**Consumers
Power
Company**

DOCKET 50-255, LICENSE DPR-20 -
PALISADES PLANT - CORRECTIONS TO ALLOWABLE
TUBE WALL DEGRADATION ANALYSIS

ANALYSIS TO DETERMINE
ALLOWABLE TUBE WALL DEGRADATION
FOR
PALISADES STEAM GENERATORS

Revision 2, March 30, 1976

SUMMARY
ELASTIC STRESS ANALYSIS
WORST CASE TUBE ROW 110

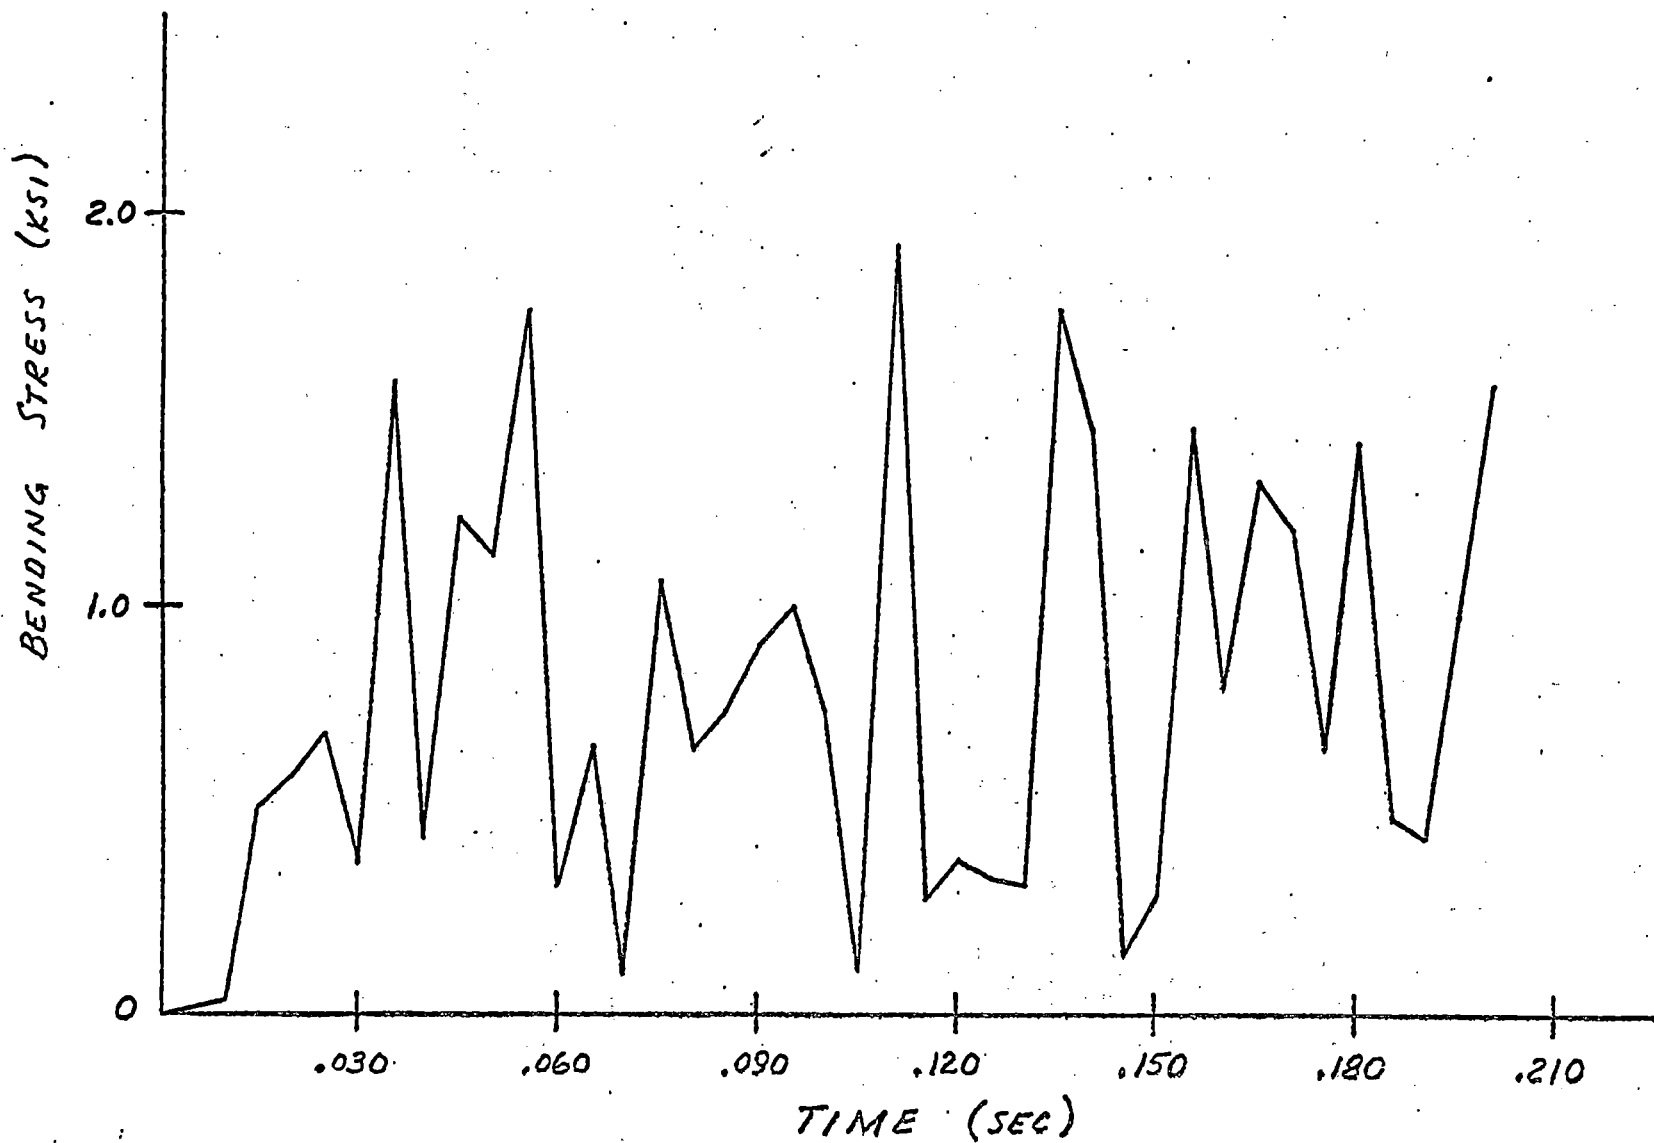
The results of the elastic LOCA + SSE analysis are summarized in Figure A.19.

A.19 A
rev. 2

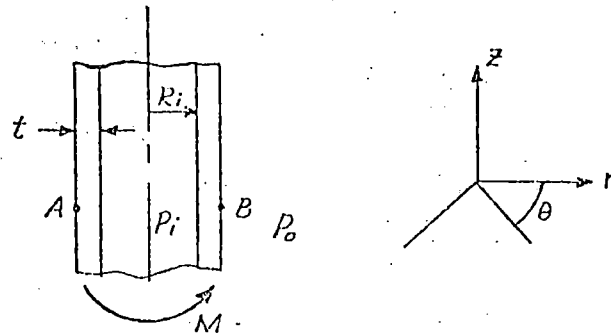
The resultant stress intensity is formed by the combination of the total compressive bending stress and the tensile hoop pressure stress. Figure A.19A presents the stress intensities determined for the healthy tube geometry and a 64% degraded tube. Results for the degraded tube indicate a stress intensity of 74.3 ksi.

Point A Point B
Stress Intensity $[23+2.2-(-0.77)] = \underline{\underline{26.0}}$ $[-23+2.2-(4.4)] = \underline{\underline{25.2}}$

Point A Point B
Stress Intensity $[67.4+6.1-(-0.77)] = \underline{\underline{74.3}}$ $[-67.4+6.1-(12.2)] = \underline{\underline{73.5}}$
